**RE: Homes Direct
601 San Jose Ave. SE
Grading & Drainage Plan
Engineer's Stamp Date: 05/06/22
Hydrology File: M14D004E**

Based upon the information provided in your submittal received 05/12/2022, the Grading & Drainage Plan is **not** approved for Grading Permit. The following comments need to be addressed for approval of the above referenced project:

Grading Plan

C-201

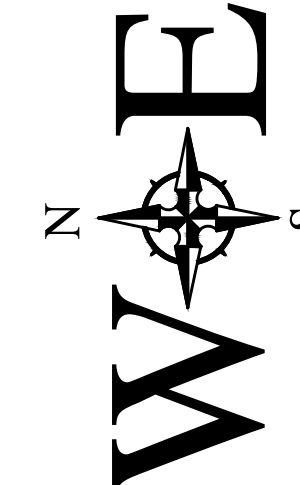
1. Please label the lot correctly. It is currently labeled as Lot 6A-1 & Lot 6A-2.
2. Since this property has been replated, the Legal Description also needs to be corrected to match this recent filing.

3. Please provide the top of wall, existing and proposed grades on both sides of the proposed garden wall. Also, please provide sections through all external boundaries showing proposed garden walls, type of footer, property/ROW lines, existing and proposed grades.

4. Please note that there cannot be any walls built within the City's Public Storm Sewer Easement and I am sure that Water Authority has similar restrictions within their Public Water line Easements. I would suggest either just installing a chain link fence or relocation the wall along the southern side of the southern most Public Waterline Easement.

5. Please use the procedure for 40 acre and smaller basins as outlined in Development Process Manual (DPM) Article 6-2(a). Please provide both the existing conditions and proposed conditions for the 100 year-6 hour storm event.

6. Under Existing Conditions, please states, "In accordance with the Broadway Industrial Center Master Drainage Management Plan by Mark Goodwin & Associates with Engineer's stamp date 1-26-99 this property has a limited discharge of 1.67 cfs/ac."

7. Please label the shaded existing private drainage access easement for Lot 5A.
8. Please note that Lot 5A was designed under M14D012G by Mark Goodwin & associates with engineering stamp date of 10/14/04. 0.28 ac of Lot 5A is allowed to discharge into the detention pond on Lot 6. This area has a discharge of 0.98 cfs and an allowable discharge rate of 0.47 cfs. Please show the off-site discharge from Lot 5A.

9. Please provide the calculations for the reshaping of the detention pond. Also, there should be an existing orifice plate within the outfall pipe or manhole. This will need to be verified. If there is not one, then an outfall structure will need to be designed and installed to limit the discharge to 5.08 cfs. (portion of Lot 5A – $1.67 \text{ cfs/ac} \times 0.28 \text{ ac} = 0.47 \text{ cfs}$) + (Lot 6 – $1.67 \text{ cfs/ac} \times 2.76 \text{ ac} = 4.61 \text{ cfs}$).

10. The existing 72" storm sewer work order plans that you had provided, if for a storm sewer just to the north and west of this project. It is in an entirely different sub-watershed and does not affect this site.
